**CITY OF LOS ANGELES**  
**INTER-DEPARTMENTAL MEMORANDUM**

Subject: **PEOPLE ST SPRING 2014 APPLICATIONS (Council File 13-1592)**

**Attachment 4: Application Summaries - Spring 2014 People St Application Cycle**

# 43<sup>rd</sup> Place Plaza

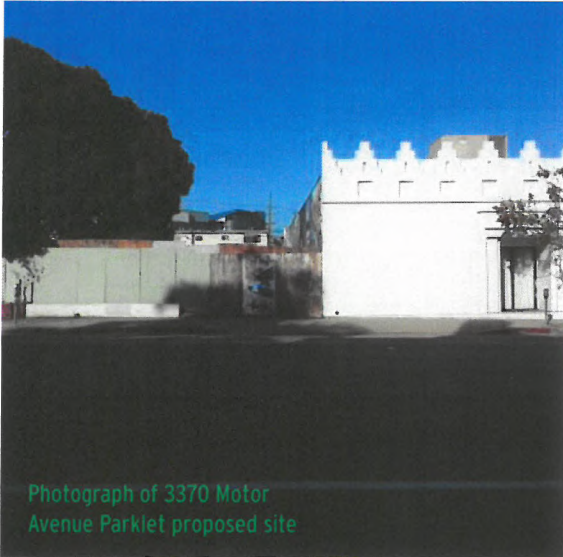
### **Conditionally recommended to proceed**

**Conditions to be fulfilled:** Prior to design development and installation, the Community Partner shall agree to pay for the costs of the roadbed surface treatment, if different from the options detailed in the People St Kit of Parts for Plazas, and shall agree to modify the footprint of the plaza as recommended by LADOT staff. See Attachment 5, Recommended Plaza Footprint for the 43rd Place Plaza.

# 3370 Motor Avenue Parklet

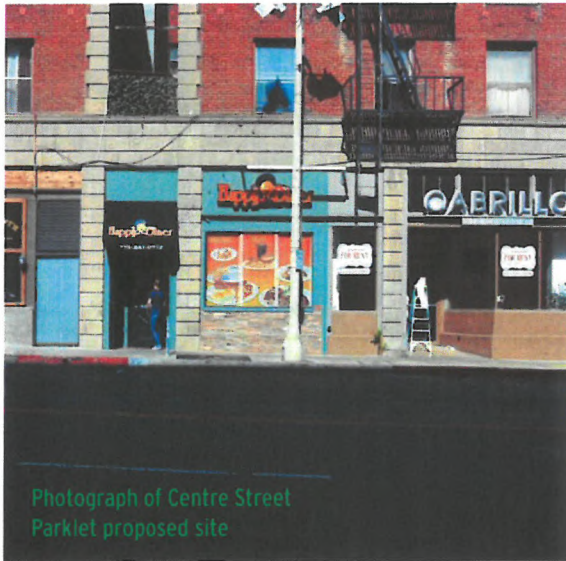
### **Conditionally recommended to proceed**

**Conditions to be fulfilled:** Prior to design development and installation, the Community Partner shall agree to either shift proposed parklet footprint to on-street parking spaces away from decommissioned driveway or pay for costs to restore curb along current footprint.

# 7<sup>th</sup> Street Parklet

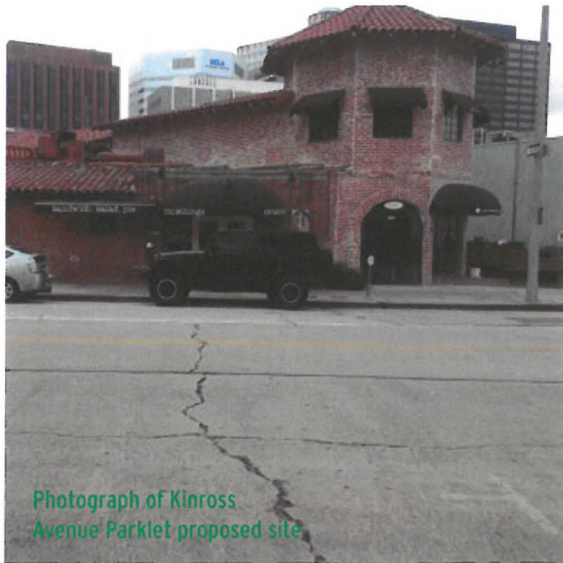
### **Recommended to reapply** **Recommendations for reapplication:**

- Secure required documentation of support from adjacent entities and demonstrate overall community support
- Proposed parklet is located on a street with incorrectly installed metered parking, with adjacent parking (commercial loading zone) too close to stop sign at intersection. Parking spaces will need to be reconfigured to meet red curb zone standard before they can be repurposed for a parklet.
- Work with closely with CD 15 and LADOT to reconfigure parking to allow for parklet installation that meets site location criteria.
